Safety Evaluation Report  
for the Renewal of  
Special Nuclear Material License SNM-1227  
for the  
Siemens Power Corporation  
Richland Engineering and Manufacturing Facility  
Richland, Washington  
Docket 70-1257

November 1996

Figure 2.1 SPC Organization

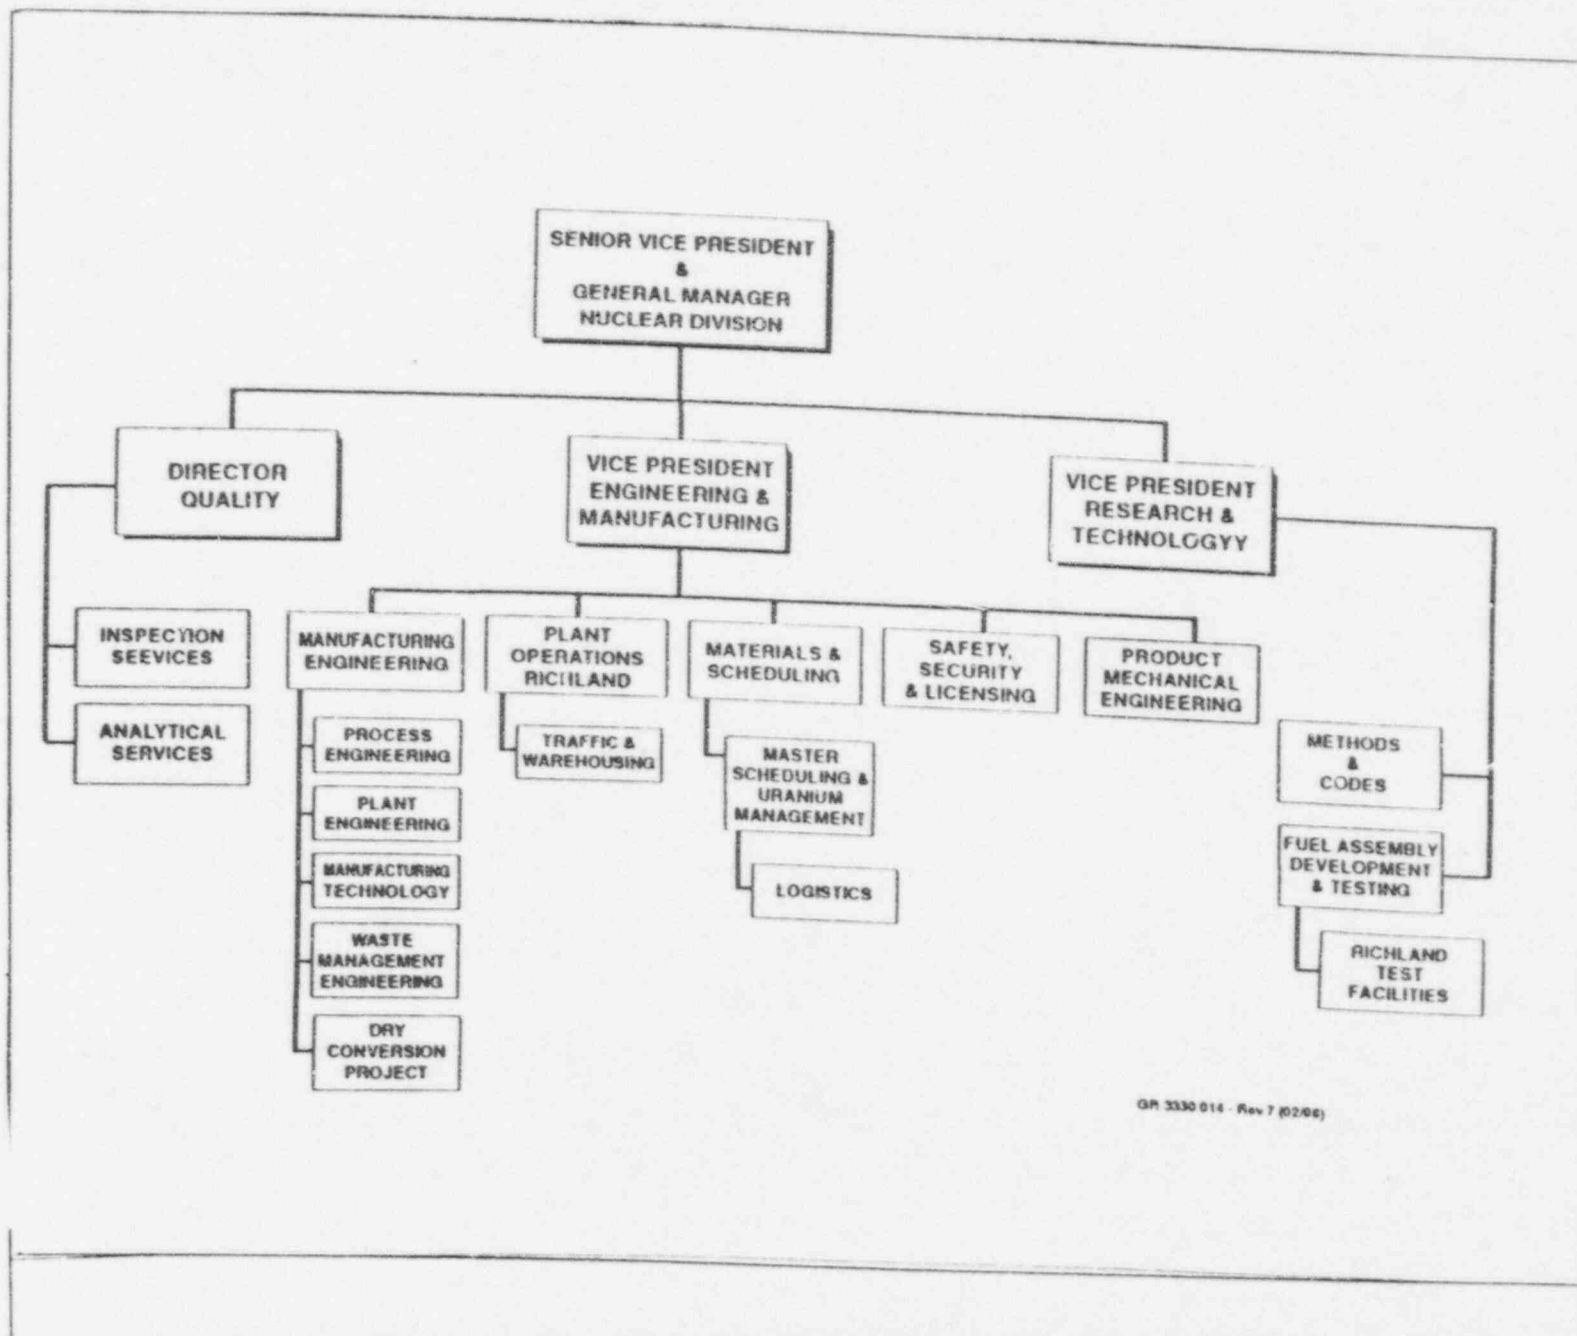
The organization charts show that the safety functions are independent of the functions of production and are therefore acceptable.
